BAYVIEW FLOOD MAPPING RESPONSE

Adopted flood study, flood mapping and Estuary Hazard Map

Figure 1: Adopted flood mapping for the Bayview locality showing mapped flood behaviour and PMF level labels in the external overland flow / road corridor. The proposed development site / footprint is not shown within the mapped flood extent.

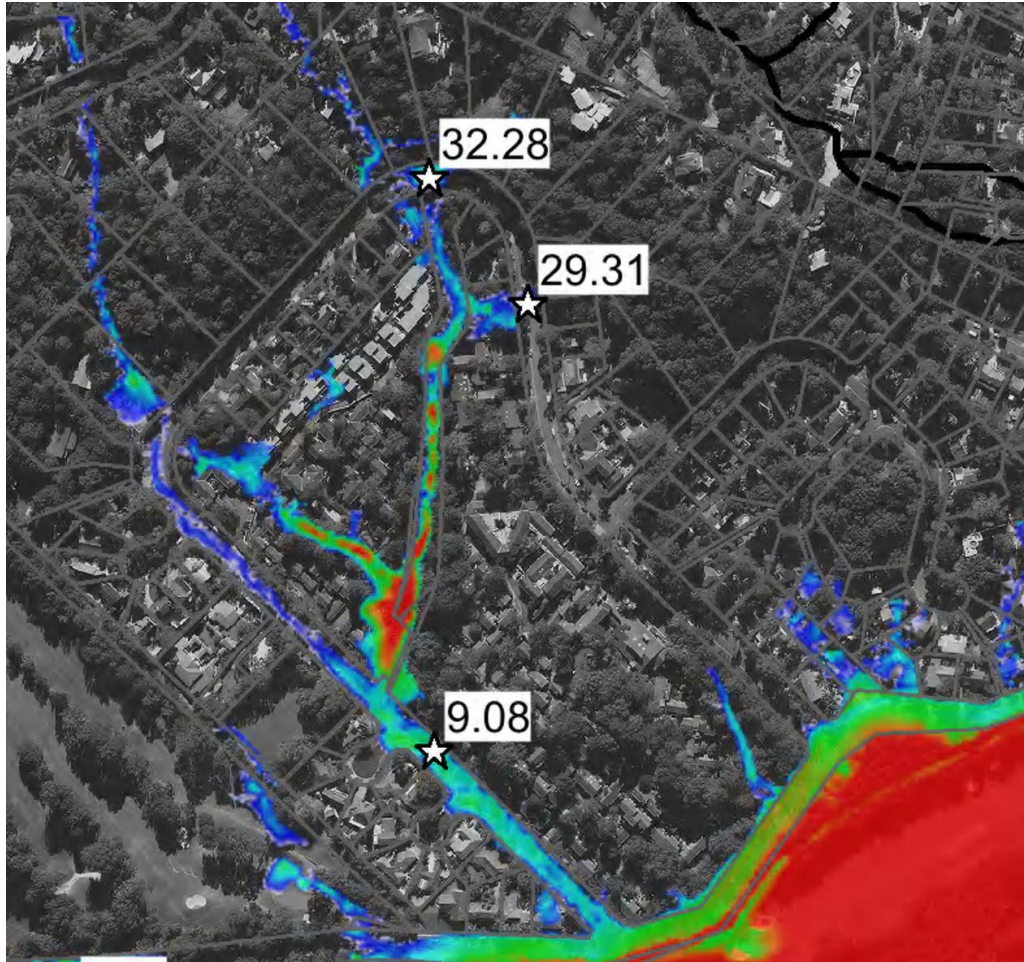
Matter raised	Project position	Proposed close-out response
Need for FIRA	The development footprint is not shown within the mapped flood extent, including the PMF flood mapping.	A standalone FIRA is not proportionate or necessary. Provide a targeted flood mapping response and survey overlay instead.
PMF information	PMF levels shown on the attached mapping are location-specific outputs along external flow paths and do not apply uniformly to the site.	Identify that the mapped PMF extent does not encroach on the proposed development footprint and that the off-site labels are not building platform flood levels.
Floor and carpark levels	Lowest proposed development level is RL 20.48 m AHD and is outside the mapped flood extent.	Confirmed all habitable floors, carpark entries and critical services are located outside mapped flood affectation.
Overland flow	Mapped overland flow is external to the development footprint and follows established drainage / road corridors.	Confirmed that the proposal does not obstruct, divert or fill mapped overland flow paths. Include a survey / drainage plan overlay if required.

The important distinction for the present development is that the mapped PMF flow paths and PMF flood level labels are shown along the external drainage / overland flow corridors and low-lying road areas. The proposed development footprint is not shown as being inundated by the mapped flood extent. Accordingly, the off-site PMF labels should not be treated as flood levels applying to the proposed building platform.

The lowest proposed development level is RL 20.48 m AHD. However, because the development footprint is outside the mapped flood extent, the primary assessment issue is not a comparison between the floor level and off-site PMF spot levels. The PMF labels shown on Figure 1 are location-specific outputs along external flow paths and should not be applied as a uniform flood level across the site. The relevant conclusion is that the mapped PMF does not extend to the development footprint.
